TECHNICAL SERVICE BULLETIN

76-B-11

Triumph

INCORRECT POSITIONING OF HORN RELAY

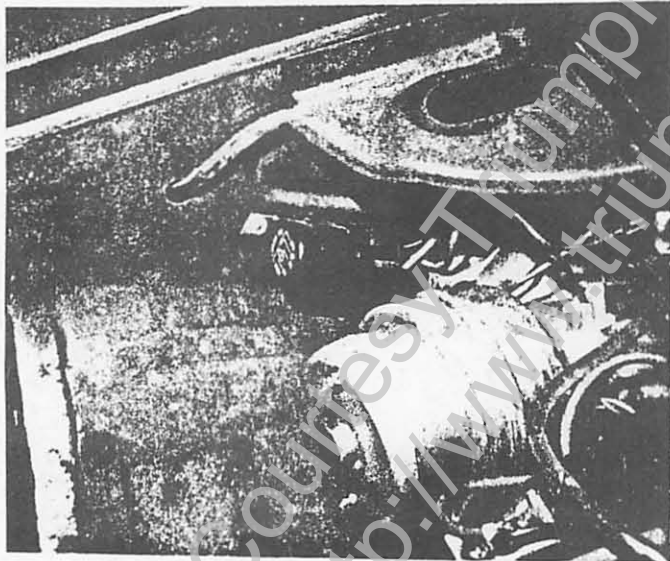
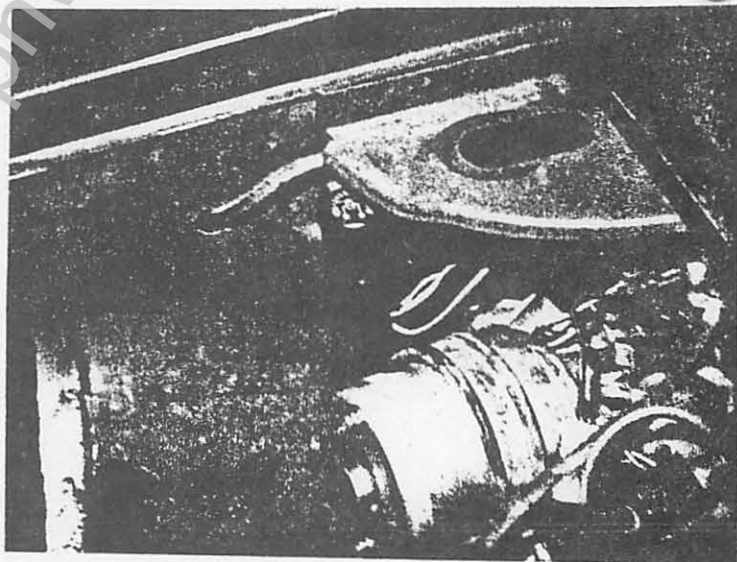
Cases have been reported where the horn relay on the TR7 has been installed in such a position as to allow water ingress.

Please check this item during pre-delivery and/or during the next customer regular servicing interval, and if necessary re-position as shown in the diagram.

INCORRECT POSITION

CORRECT POSITION
